CITY OF ALBUQUERQUE

Re: McMahon Marketplace Taproom
5720 McMahon Market Place NW
30-Day Temporary Certificate of Occupancy- Transportation Development
Transportation Development Final Inspection
Engineer's/Architect's Stamp dated 8-25-17 (A11D011H)
Certification dated 04-27-18

SHEET NO: **A1.1**

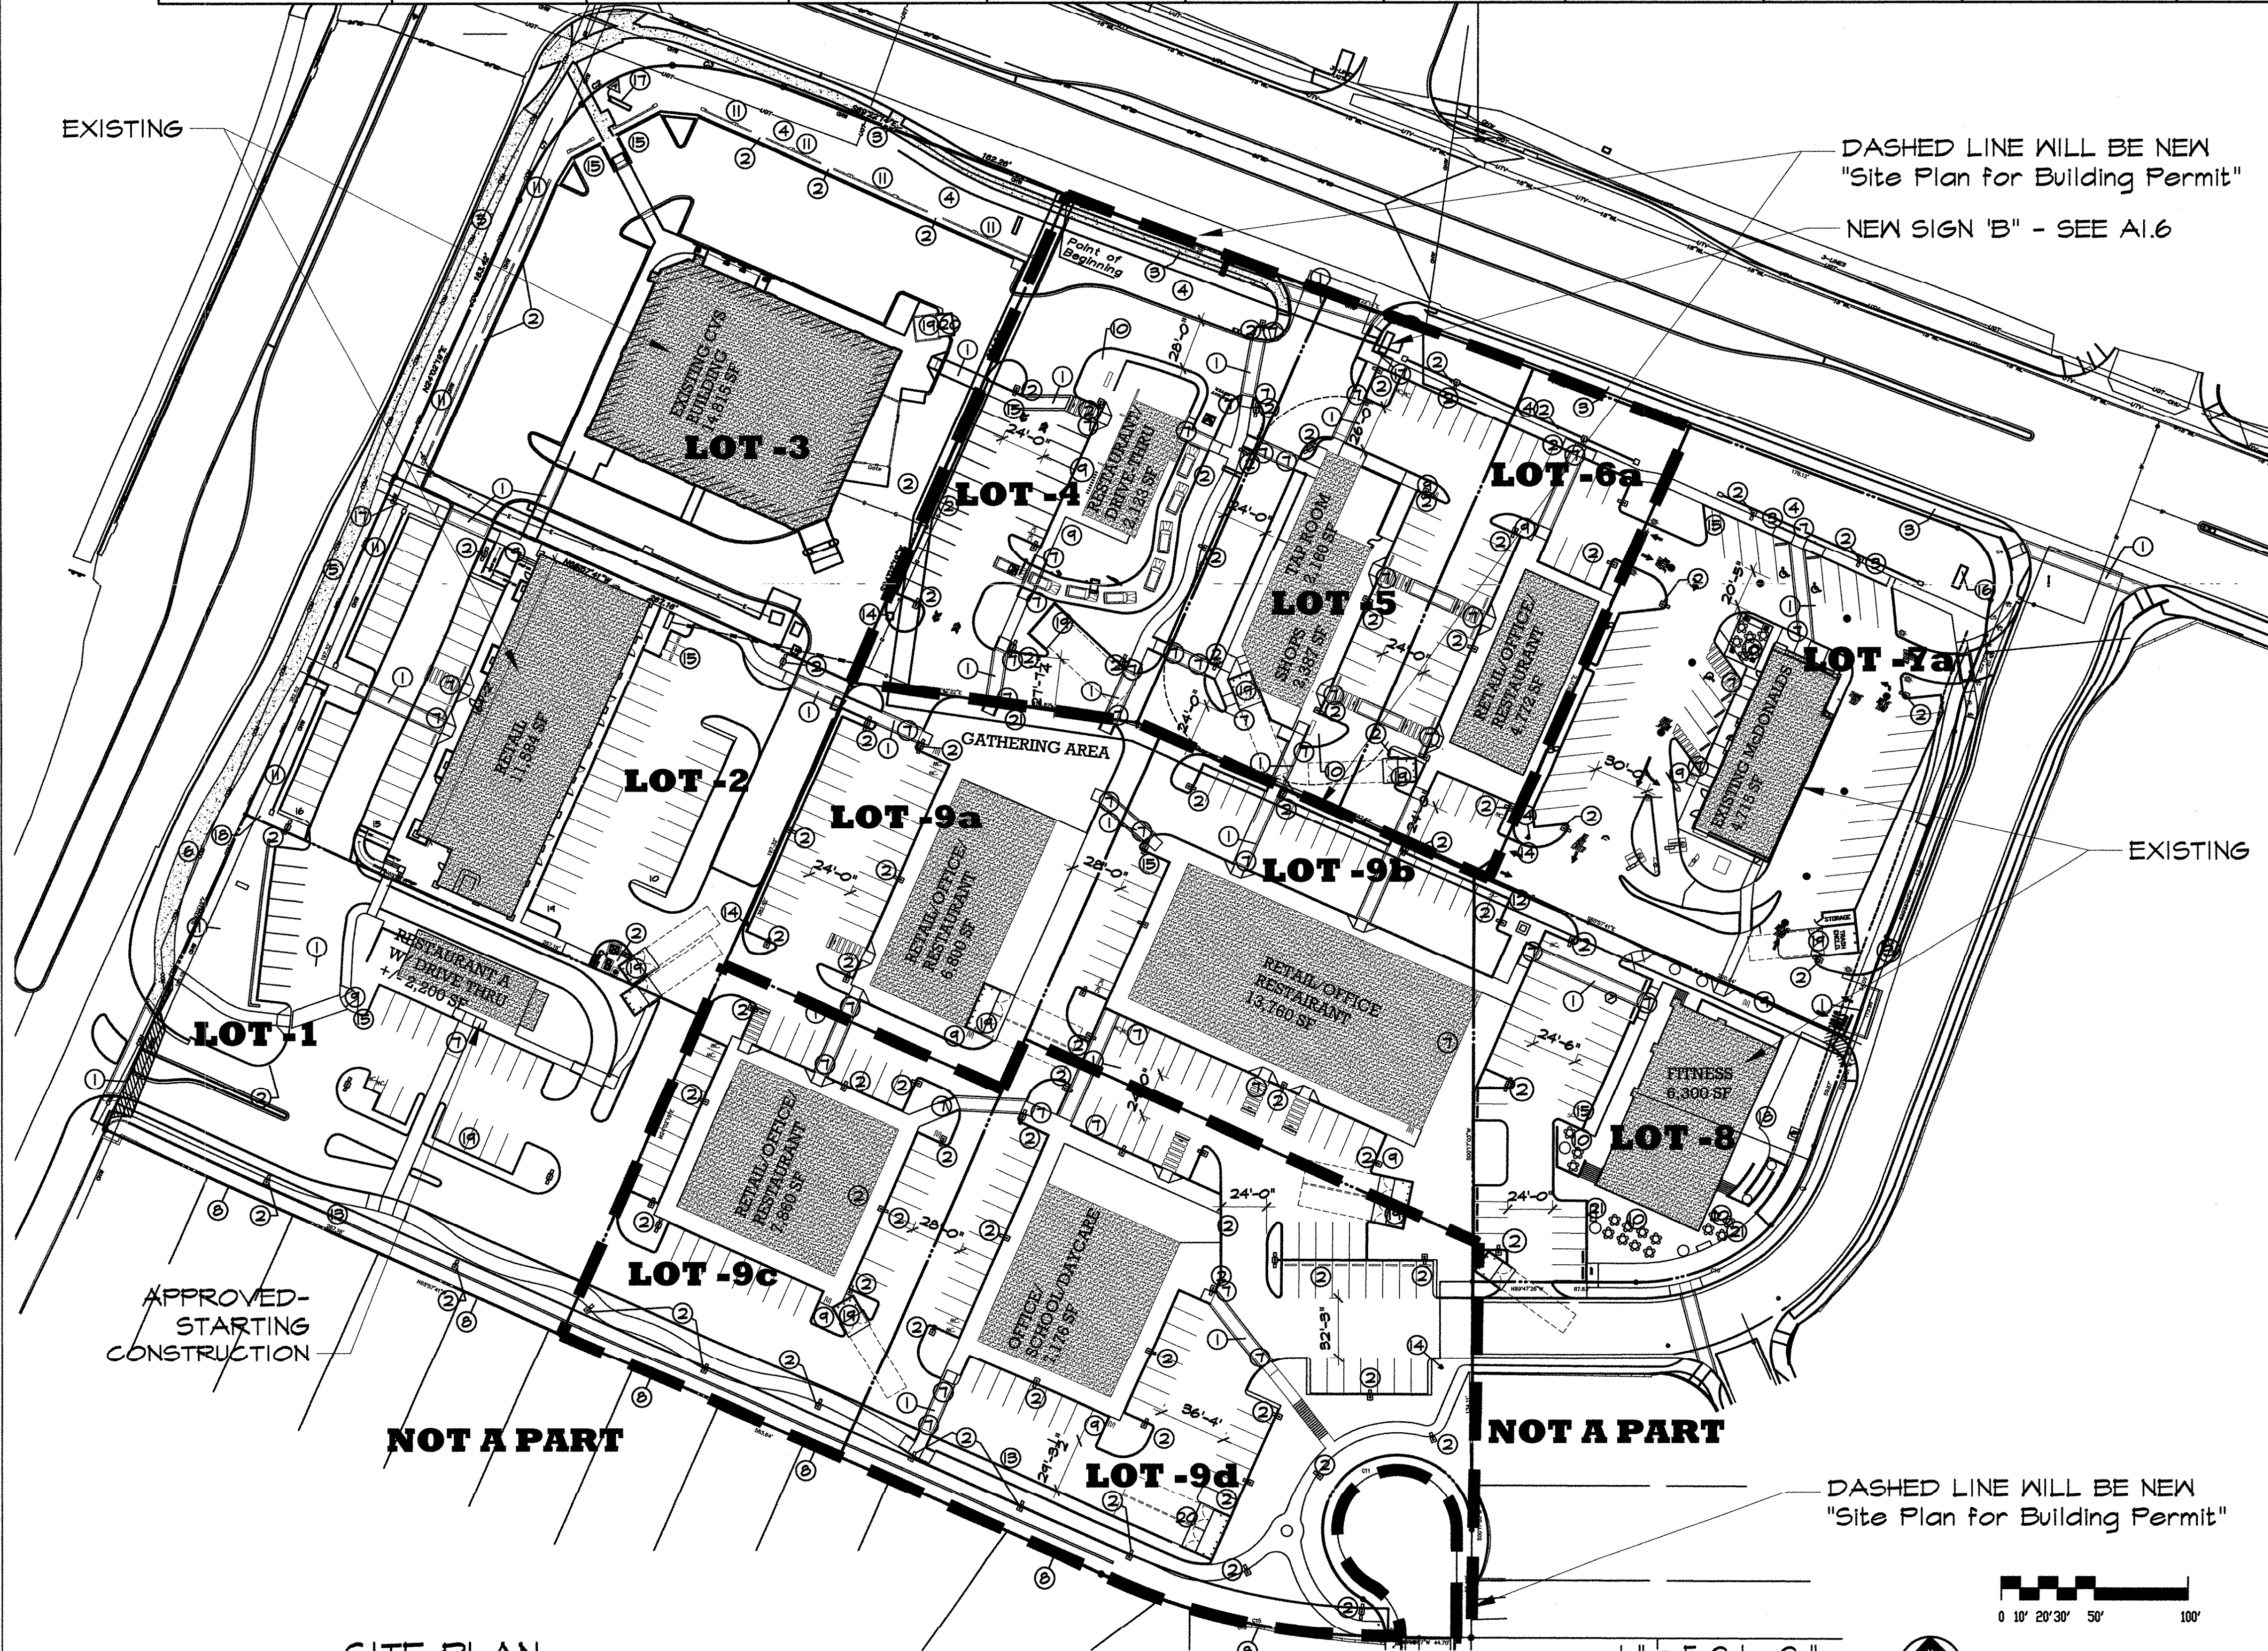
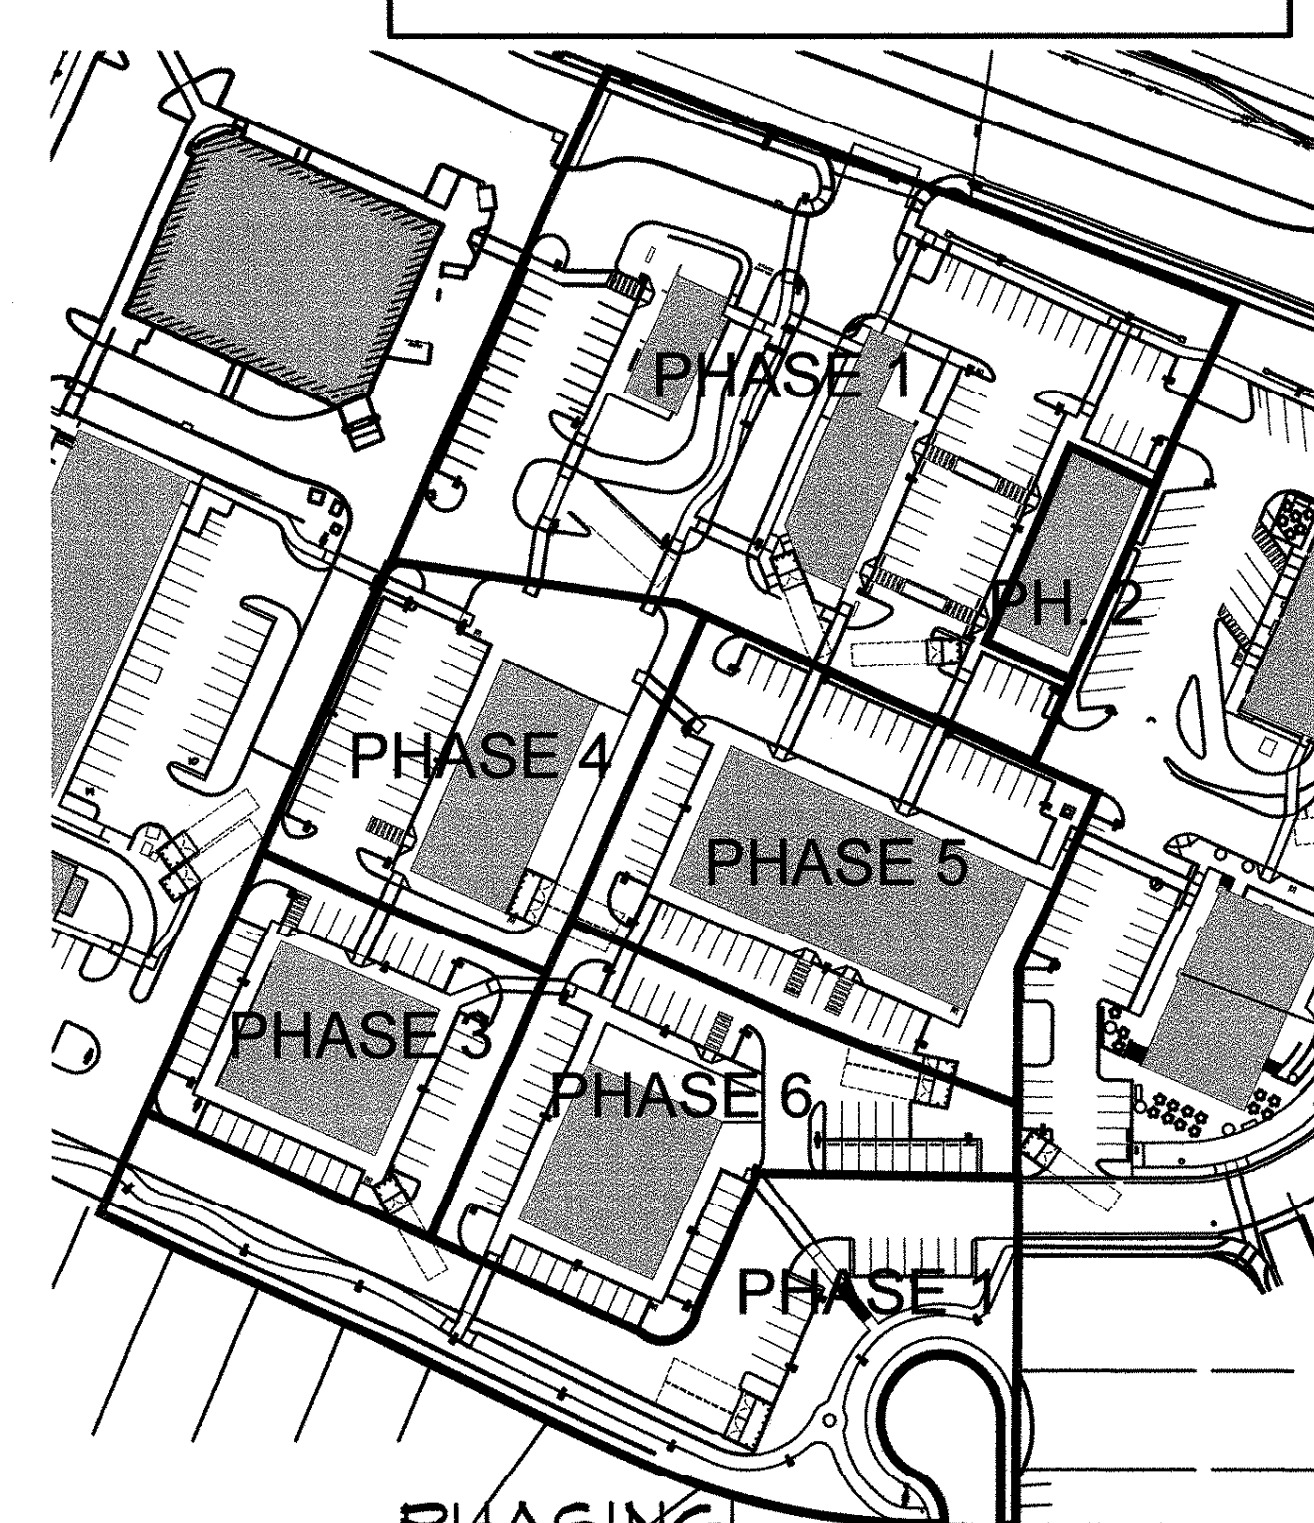
1. Missing Motorcycle parking signs.
